Hummingbird Energy LLC
Second Set of Supplemental Responses to Siting Board Staff's First Request for Information
Case No. 2022-00272

HUMMINGBIRD SOLAR PROJECT

Title
CONCEPTUAL LAYOUT
OVERALL SITE

Project No. 193708901	Scale NTS
Revision Sheet E	Drawing No. C200

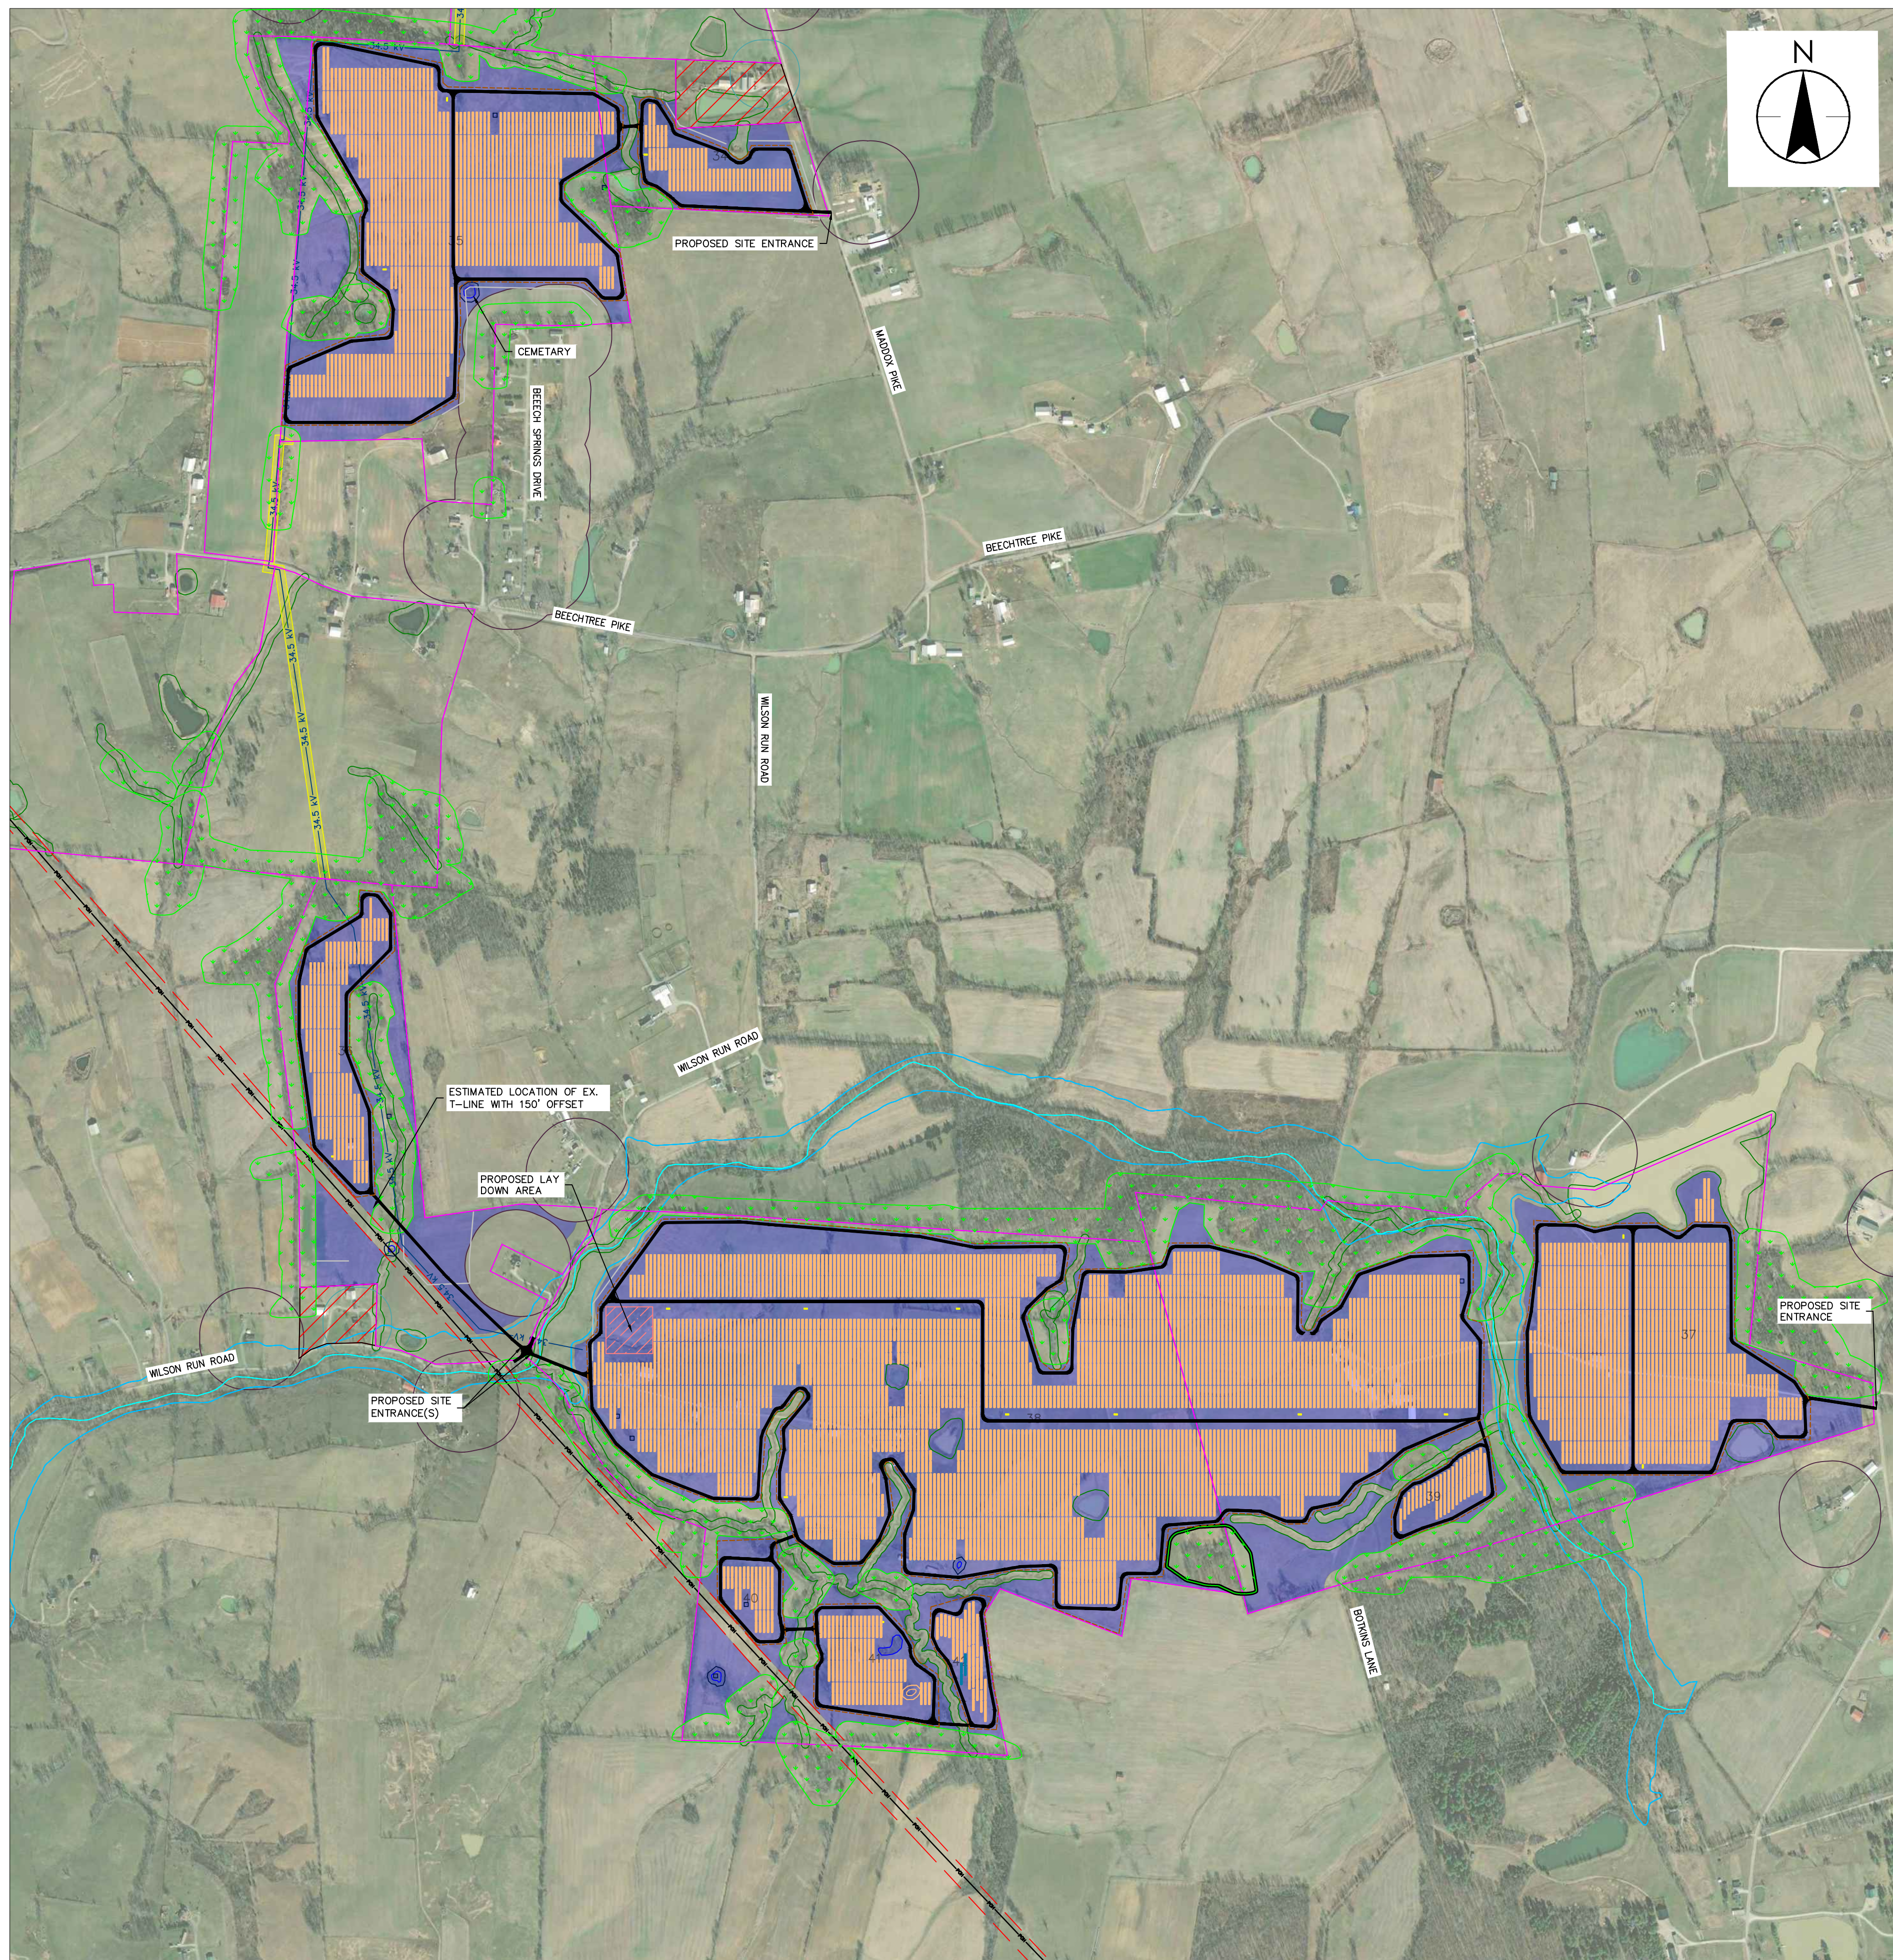
List of Changes to C200-5

- Karst feature relabeled as cemetery with label added (same as on C200-4).
- Entrance road added that extends from Wilson Run Road to near the laydown road.

C203: Public Resources within 2 Miles of the Study Area

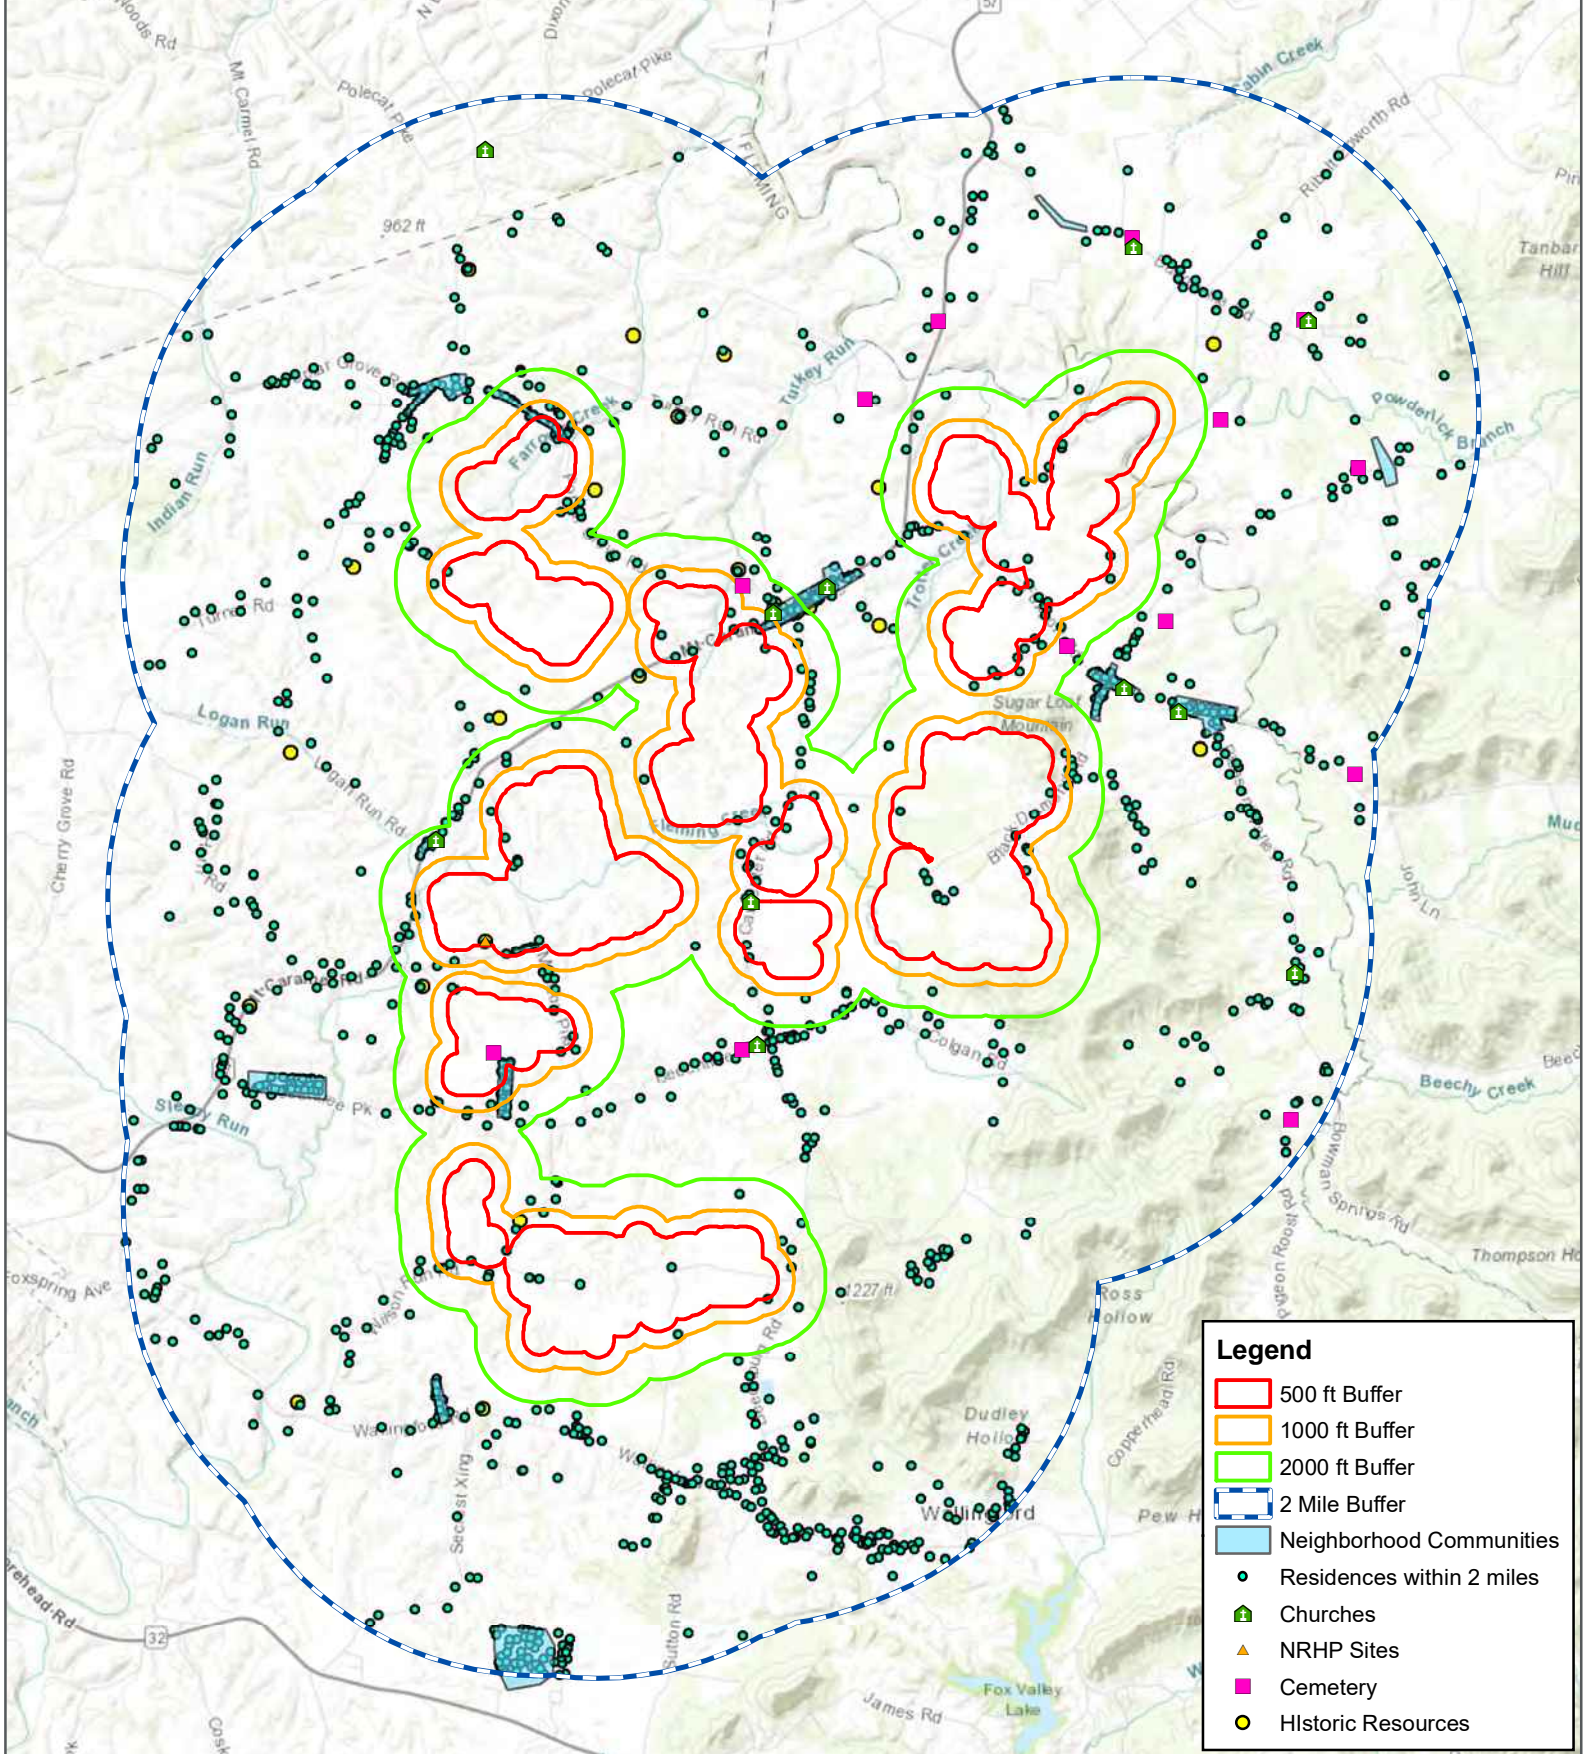
List of Changes to C203

- Two cemeteries added near Bowman Springs Road and John Lane.
